DEVELOPMENT APPLICATION ASSESSMENT REPORT

Application Number:	DA2021/1059
----------------------------	-------------

Responsible Officer:	Adam Croft
Land to be developed (Address):	Lot 13 DP 29355, 56 Peronne Avenue CLONTARF NSW 2093
Proposed Development:	Alterations and additions to a dwelling house and family flat, including the construction of a swimming pool and associated landscape works
Zoning:	Manly LEP2013 - Land zoned R2 Low Density Residential
Development Permissible:	Yes
Existing Use Rights:	Yes
Consent Authority:	Northern Beaches Council
Delegation Level:	DDP
Land and Environment Court Action:	No
Owner:	Nicole Rosalie Adamo
Applicant:	Minto Planning Services Pty Ltd

Figure 1. Height non-compliance of existing and proposed roof forms.

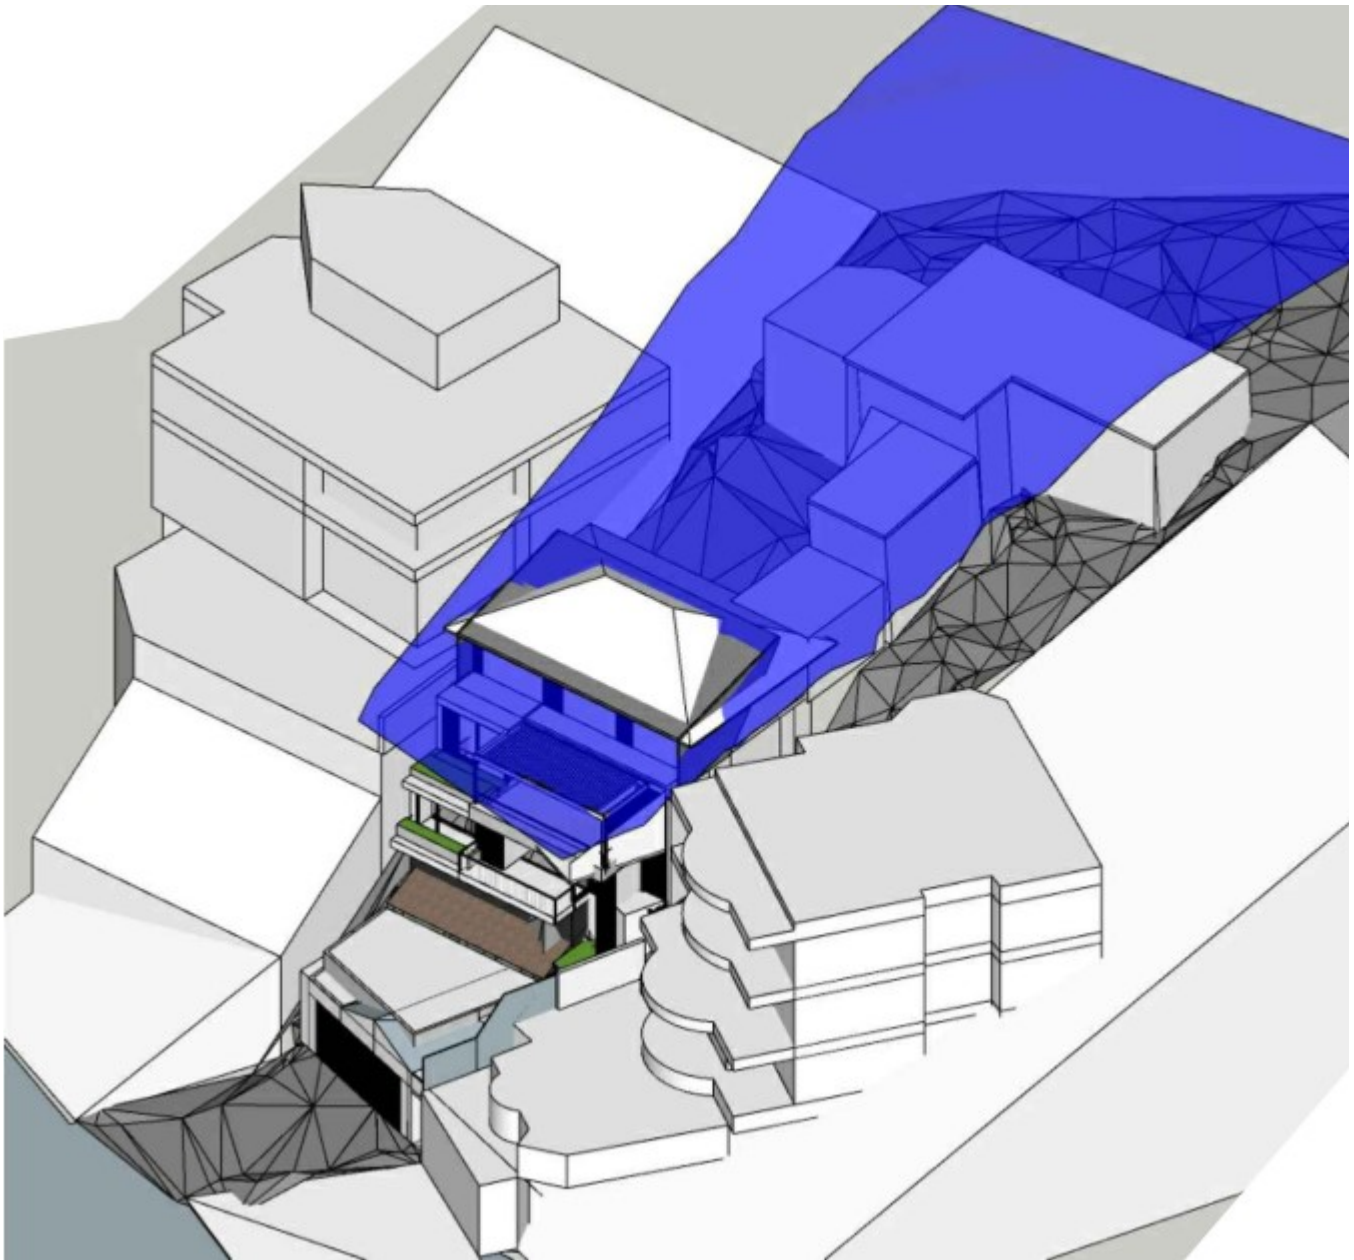
The proposed variation occurs due to the proposed new skillion roof design over the existing dwelling that already exceeds the building height control. The overall height of the dwelling is increased by a maximum of 150mm, while the ridge height of the roof is reduced by 510mm. Despite the increased height of the dwelling, the proposal is considered to reduce the bulk of the roof form above the 8.5m height plane and maintain a reasonable level of amenity to adjoining properties and the public domain. Figure 1 below illustrates the building height non-compliance and redistribution of bulk resulting from the proposed skillion roof (grey) in comparison to the existing hipped roof (white).

In this regard, the applicant's written request has demonstrated that the proposed development is an orderly and economic use and development of the land, and that the structure is of a good design and amenity, therefore satisfying cls 1.3 (c) and (g) of the EPA Act.
